Attachment A

1. Replace Technical Specification page 6.2-2 with the enclosed page.

Amendment No. ~~15, 21, 35, 42~~  
PROPOSED

Figure 6.2-1

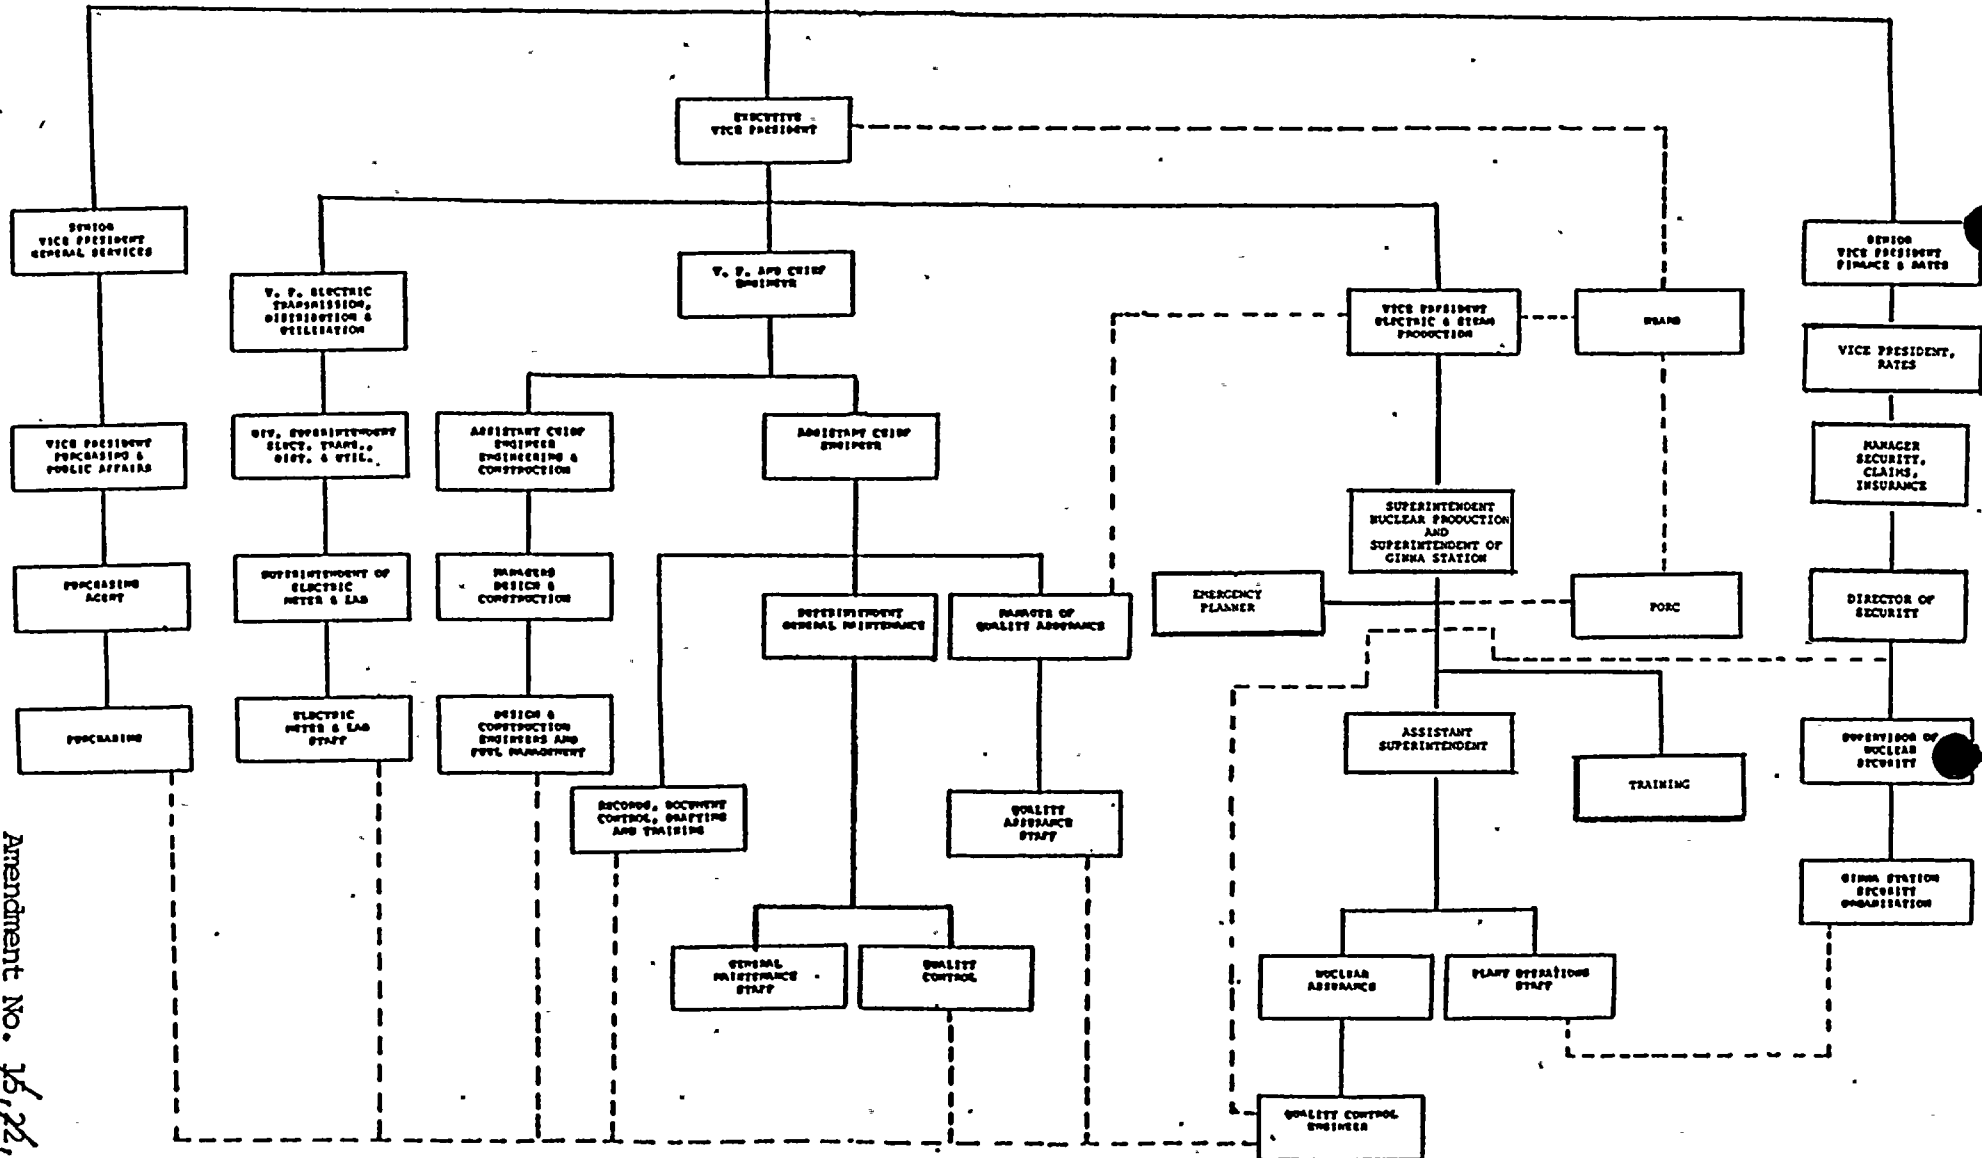
The change involves the consolidation of the position of Superintendent of Nuclear Production with the position of Superintendent of Ginna Station. The result is the addition of responsibilities for corporate emergency planning to the current responsibilities of the Ginna Superintendent. It is estimated that other new responsibilities will require only a small amount of the Superintendent's time.

The consolidation of responsibilities will not reduce management attention to the operation of Ginna and will not affect the health and safety of the public.
